# UNITED STATES PATENT AND TRADEMARK OFFICE

APPLICATION NO.	FILING DATE	FIRST NAMED INVENTOR	ATTORNEY DOCKET NO.	CONFIRMATION NO.
10/530,570	04/07/2005	Heino Foersterling	123209	8991
25944 7590 04/30/2008 OLIFF & BERRIDGE, PLC P.O. BOX 320850 ALEXANDRIA, VA 22320-4850				
EXAMINER				
BURCH, MELODY M				
ART UNIT		PAPER NUMBER		
3683				
MAIL DATE		DELIVERY MODE		
04/30/2008		PAPER

### Office Action Summary

## **DETAILED ACTION**

【 図 1 】

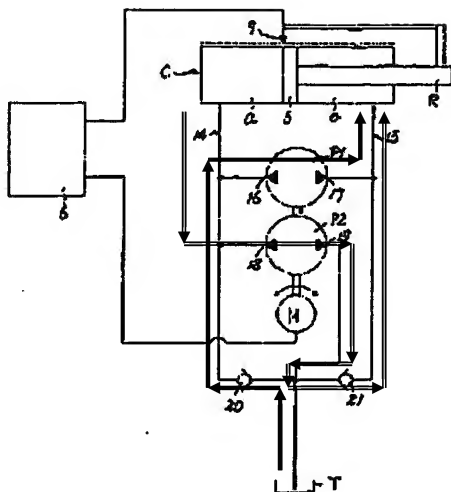
With regards to the 103 rejections, Applicant amended claim 14 to read that the "second hydraulic unit is arranged in a pressure medium flow path between the ring chamber and the cylinder chamber and the first hydraulic unit is arranged in a pressure medium flow path between the tank and the ring chamber whereby the pressure medium flow path is bypassing the second hydraulic unit." The claimed pressure medium flow paths have been illustrated in the annotated version of figure 1 of JP'403 on the following page for Applicant's convenience:

Examiner notes that the double line arrows represent a pressure medium flow path in which the second hydraulic unit P2 is arranged which extends between the ring chamber and the cylinder chamber in which is arranged as illustrated. The solid line arrows represent a pressure medium flow path in which the first hydraulic unit P1 is arranged which extends between the tank T and the ring chamber as illustrated. The annotated version of figure 1 clearly illustrates that the pressure medium flow path in which the first hydraulic unit is arranged bypasses the second hydraulic unit. Accordingly, the rejections have been maintained.
